P802.1ASdm/D1.3 October 12, 2023

Draft Standard for Local and metropolitan area networks—

Timing and Synchronization for Time-Sensitive Applications

Amendment: Hot Standby

Figure 7-7—Model for PTP Instance and its interfaces to higher-layer applications model

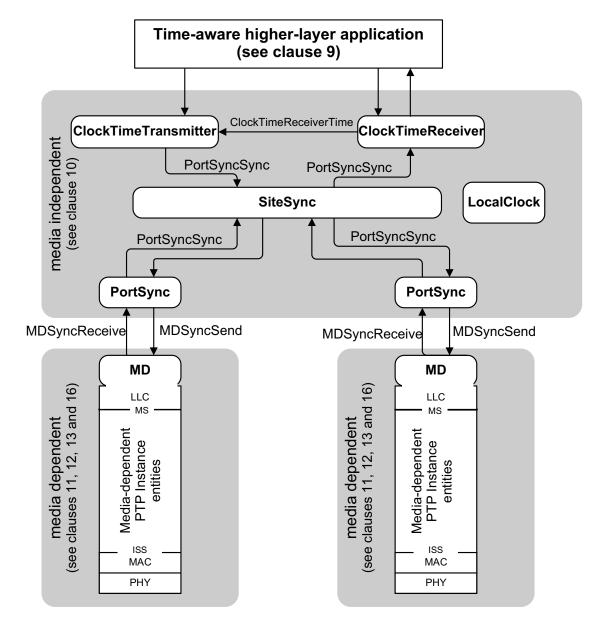
Change the first paragraph of 7.4 and the caption of Figure 7-8 as follows:

The model of a PTP Instance <u>and its interfaces to higher-layer applications are is</u> shown in Figure 7-7. The <u>interfaces are those specified in Clause 9.</u>

Figure 10-6—Clock Time Transmitter Sync Offset state machine

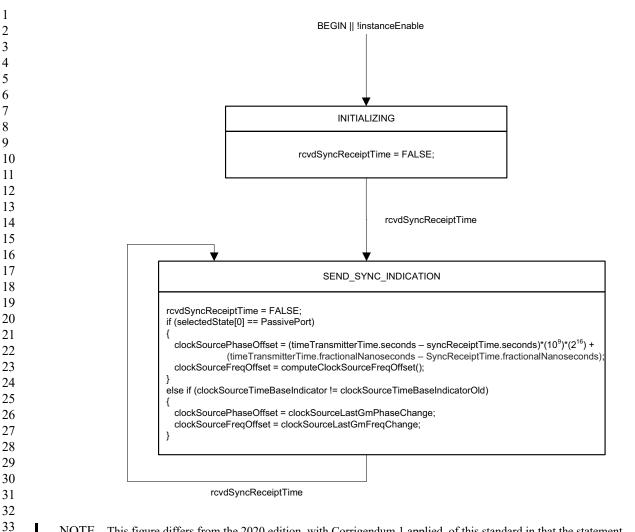
Replace Figure 10-6 with the following:

NOTE—This figure differs from the 2020 edition, with Corrigendum 1 applied, of this standard in that the statement clockSourcePhaseOffset = timeTransmitterTime.seconds – syncReceiptTime; in the SEND_SYNC_INDICATION state is replaced by clockSourcePhaseOffset = (timeTransmitterTime.seconds – syncReceiptTime.seconds)*(10⁹)*(2¹⁶) +

Figure 10-16—PortAnnounceInformationExt state machine

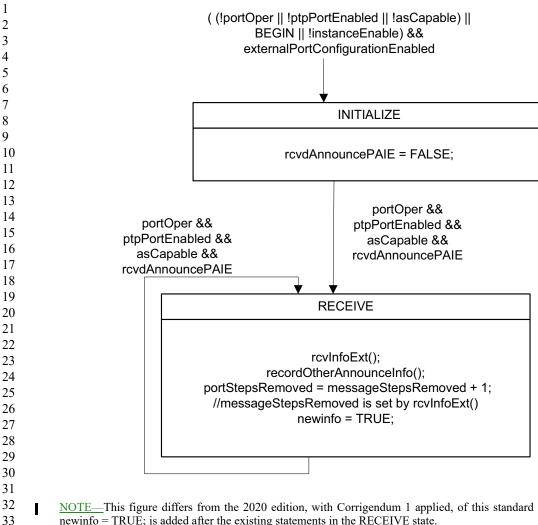
NOTE—This figure differs from the 2020 edition, with Corrigendum 1 applied, of this standard in that the statement newinfo = TRUE; is added after the existing statements in the RECEIVE state.

Figure 10-17—PortStateSettingExt state machine

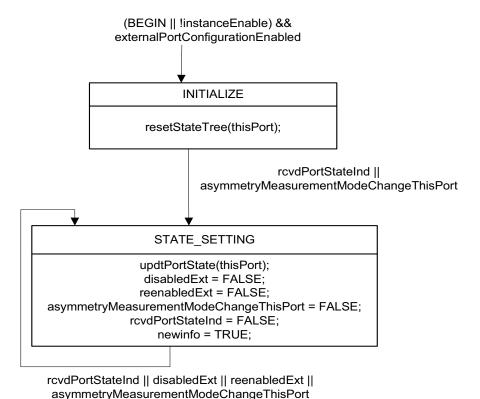
<u>NOTE 2</u>—This figure differs from the 2020 edition, with Corrigendum 1 applied, of this standard in that the statement newinfo = TRUE; is added after the existing statements in the STATE_SETTING state.

Figure 10-18—PortAnnounceTransmit state machine

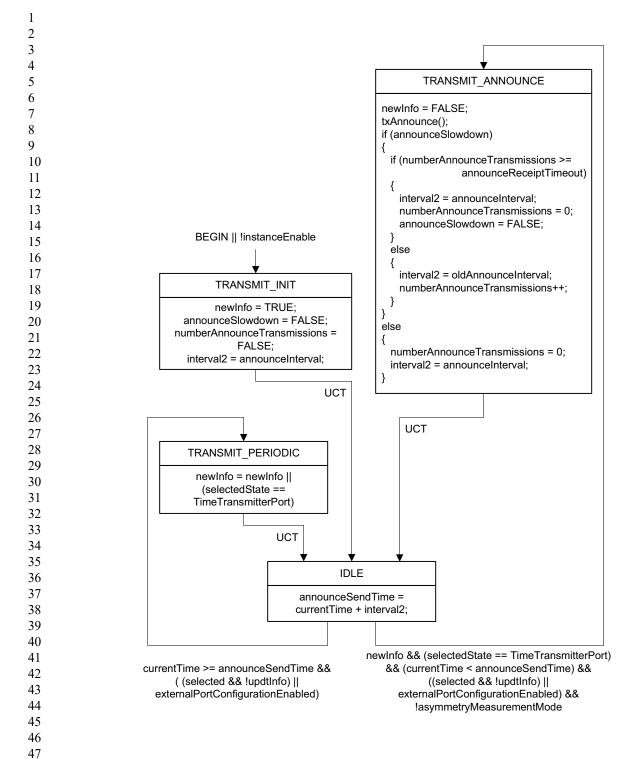
Replace Figure 10-18 with the following:

NOTE 2—This figure differs from the 2020 edition, with Corrigendum 1 applied, of this standard in that the statement interval 2 = announceInterval is added after the existing statements in the TRANSMIT INIT state.

Figure 11-6—MDSyncReceiveSM state machine

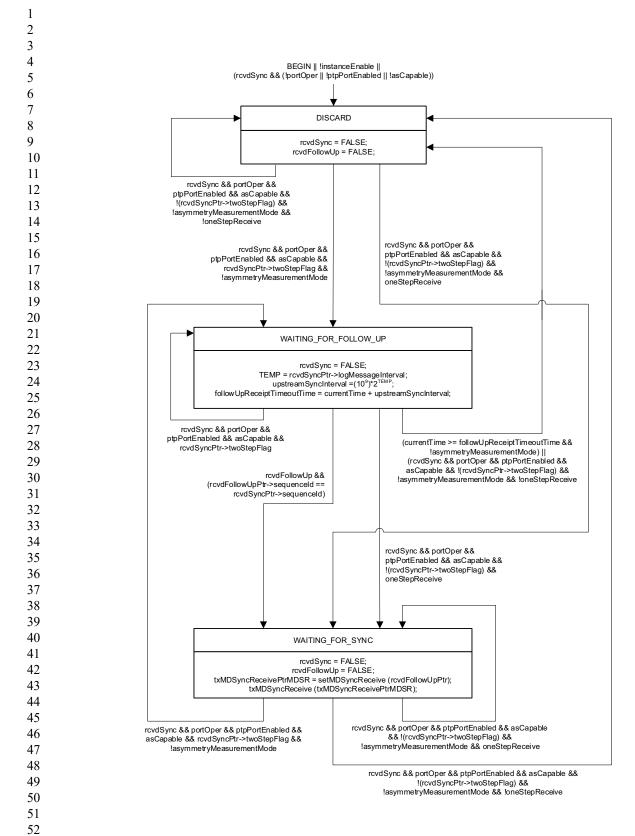
Replace Figure 11-6 with the following:

NOTE—This figure differs from the 2020 edition, with Corrigendum 1 applied, of this standard in that the variable portEnabledOper at the entry to the DISCARD state is changed to portOper.

Figure 11-7—MDSyncSendSM state machine

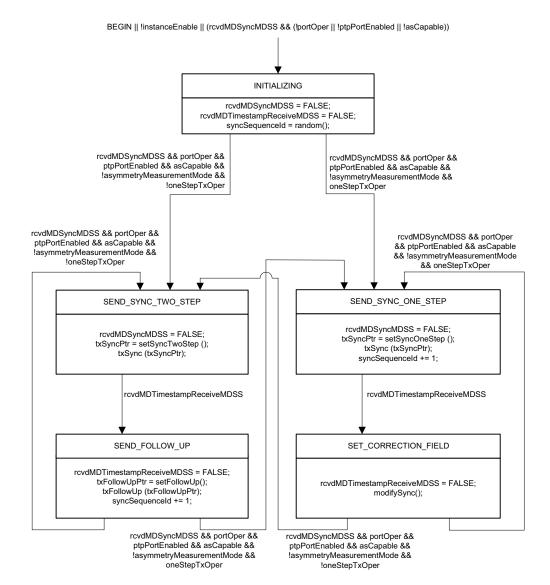
Replace Figure 11-7 with the following:

NOTE—This figure differs from the 2020 edition, with Corrigendum 1 applied, of this standard in that (a) the variable portEnabledOper is changed to portOper on the links between the SEND_FOLLOW_UP and SEND_SYNC_TWO_STEP states, between the SEND_FOLLOW_UP and SEND_SYNC_ONE_STEP states, and between the SET_CORRECTION_FIELD and SEND_SYNC_TWO_STEP states; and (b) the statement 'syncSequenceId += ' in the last line of the SEND_SYNC_TWO_STEP state is moved to the last line of the SEND_FOLLOW UP state.

Figure 11-9—MDPdelayReq state machine

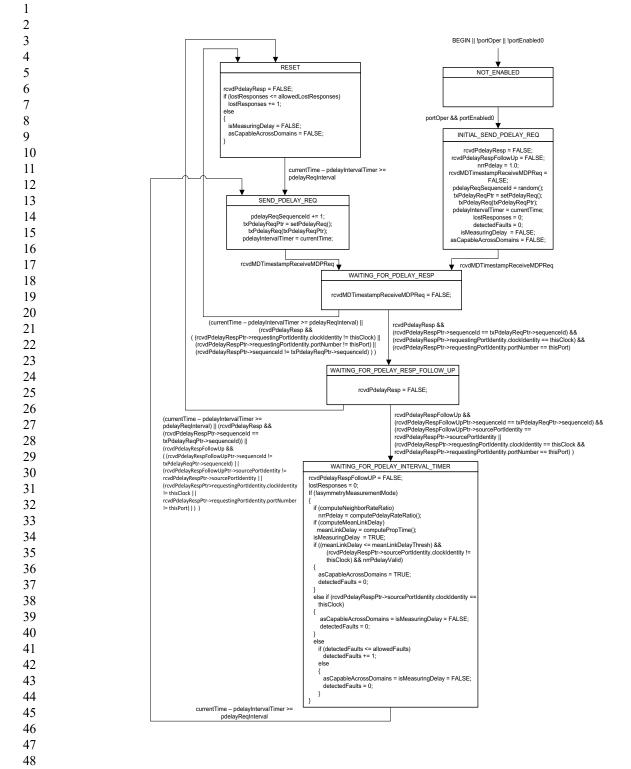
Replace Figure 11-9 with the following: 6 8 Delete the NOTE immediately after Figure 11-9.

NOTE—This figure differs from the 2020 edition, with Corrigendum 1 applied, of this standard in that (a) the condition "else if (rcvdPdelayRespPtr->sourcePortIdentity.clockIdentity != thisClock)" in the state WAITING_FOR_PDELAY_INTERVAL_TIMER is changed to "else if (rcvdPdelayRespPtr->sourcePortIdentity.clockIdentity == thisClock)" (i.e., "!=" is changed to "=="), and (b) the variables neighborRateRatio and neighborRateRatio Valid are replaced by nrrPdelay and nrrPdelayValid, respectively.

Figure 17-1—Overview of YANG tree

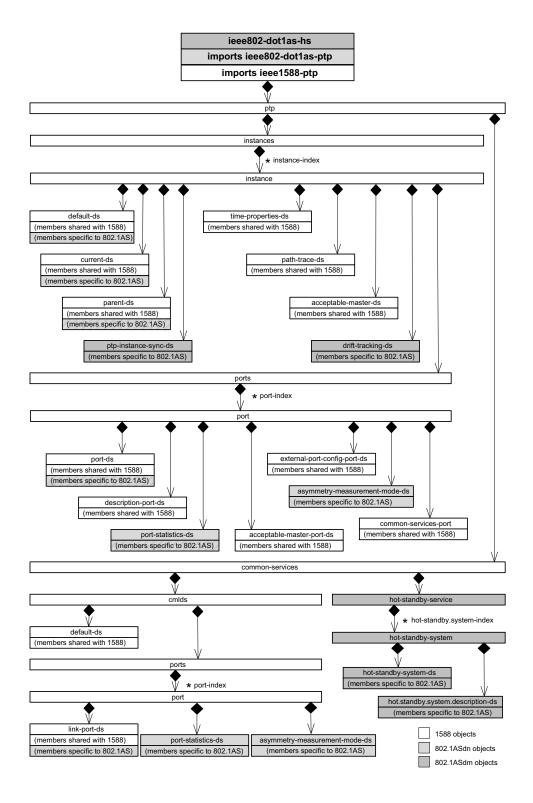
Replace Figure 17-1 with the following:

NOTE 1—This figure differs from the 2020 edition of this standard with Corrigendum 1 applied and as amended by IEEE Std 802.1ASdn in that managed objects needed for the hot standby and Drift_Tracking TLV features are added.

Figure 17-2—PTP Instance detail

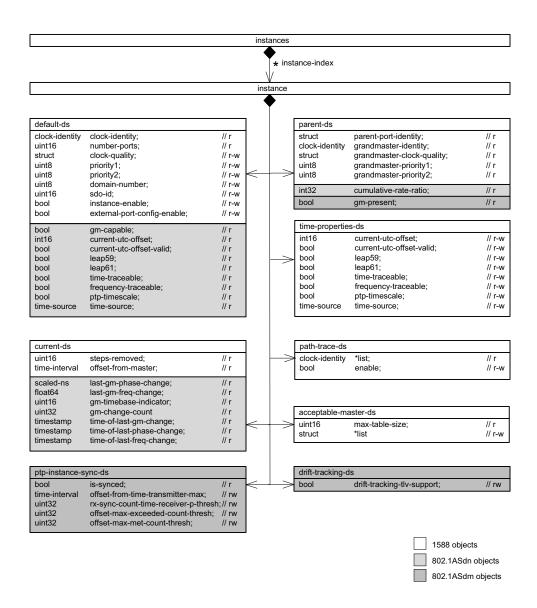
Replace Figure with the following:

NOTE 2—This figure differs from the 2020 edition of this standard with Corrigendum 1 applied and as amended by IEEE Std 802.1ASdn in that managed objects needed for the hot standby and Drift_Tracking TLV features are added.

Figure 17-3—PTP Port detail

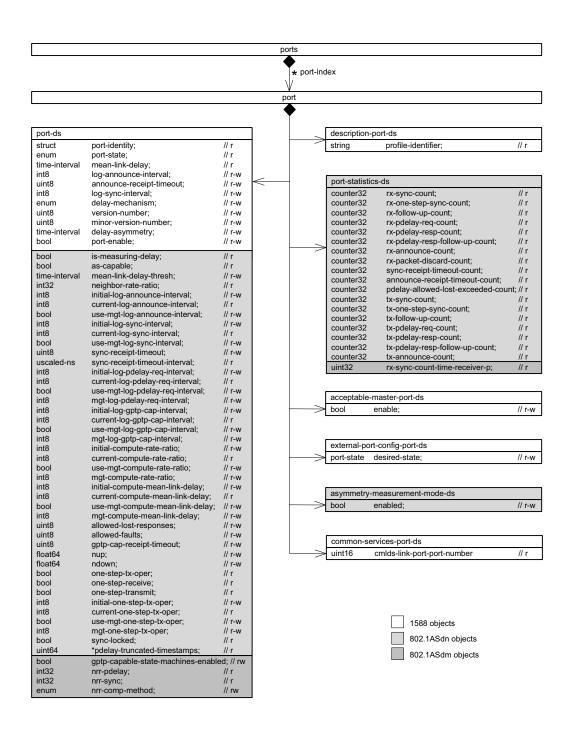
Replace Figure with the following:

NOTE 3—This figure differs from the 2020 edition of this standard with Corrigendum 1 applied and as amended by IEEE Std 802.1ASdn in that managed objects needed for the hot standby and Drift_Tracking TLV features are added.

Figure 17-4—Common services detail

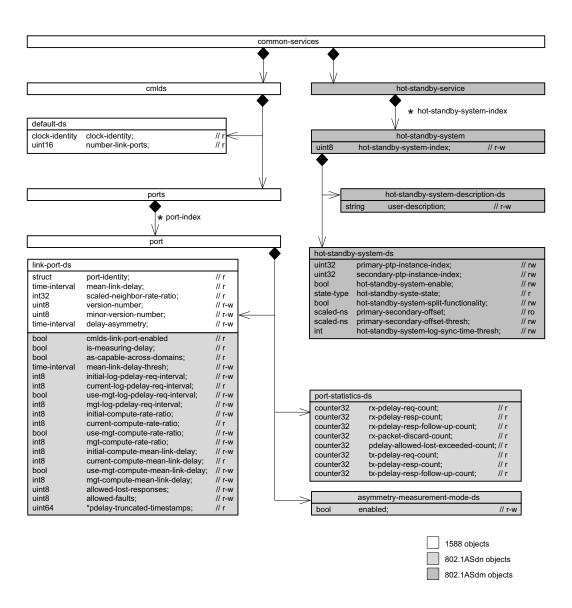
NOTE 4—This figure differs from the 2020 edition of this standard with Corrigendum 1 applied and as amended by IEEE Std 802.1ASdn in that managed objects needed for the hot standby and Drift_Tracking TLV features are added.
